Rangitoopuni – Comments Tracker

Name		S67 Comments	Site visit	<u>Preliminary</u>	
(Lead)	<u>Specialism</u>		Required		Preliminary Comments
Name (Lead) Emma Chandler	Specialism Planning	 Plan Information There is information lacking with respect to the following aspects of the development which directly relates to confirming the relevant reasons for consent under the AUP: OP: a. Site Coverages (building coverage) for Lot 2 (Retirement village site) for both pre- and post-subdivision; b. Volume of earthworks within the flood plain and riparian margins. c. Are any buildings or structures proposed that will be located on "Land that may be subject to instability" and if so is consent required under E36.4.1 (A51)? d. A plan that clearly shows the dimensions of the proposed accessways to confirm the applied for non-compliances relating to E27 of the RMA. e. A plan that clearly shows the proposed subdivision layout against the underlying zoning, noting that the site is splitzoned and this is required to understand the relationship of the CSL subdivision with the Rural Production Zone. Please provide updated plans and or information that confirms the above matters. Retirement Village Plant

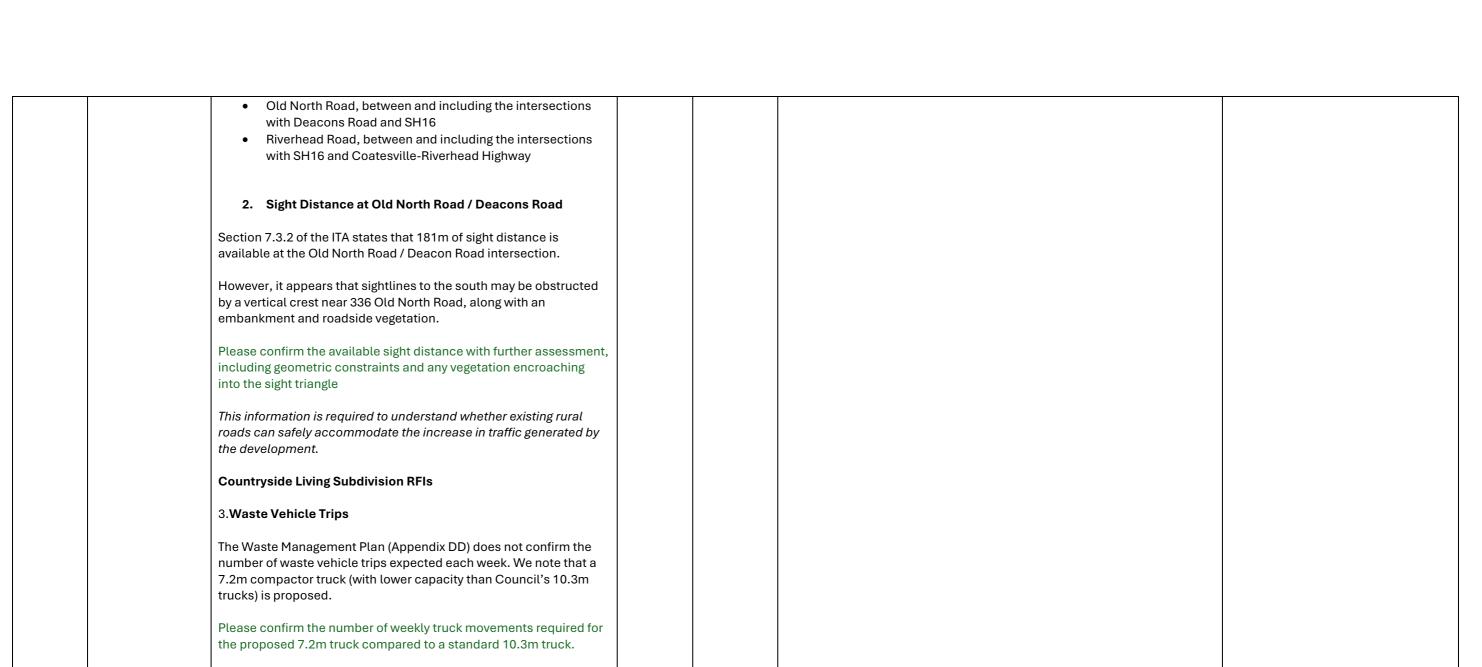
II. A gate is proposed on the access way north of Access 2.	
It should be demonstrated that vehicles would not	
queue back onto Old North Road from the gate.

i) Access 3, 4 and 5 should be clearly identified on the	
plans and an assessment of the visibility as these	
accesses provided.	
j) An assessment should be provided as to whether an upgrade to	
the Forestry Road / Deacon Road intersection is required with the	
increased development flows

k) For the upgrade of Forestry Road, the following information is	
required	
required	
I. Tracking of a 6.3m van and a 10.3m truck is required to	
demonstrate that these vehicles can pass without	
conflict.	
II. Where vehicle crossings need to be amended for the	
revised vertical (and horizontal) alignment of Forestry	
Road, confirmation of approval for such works within	
private property should be provided by the property	
owners.
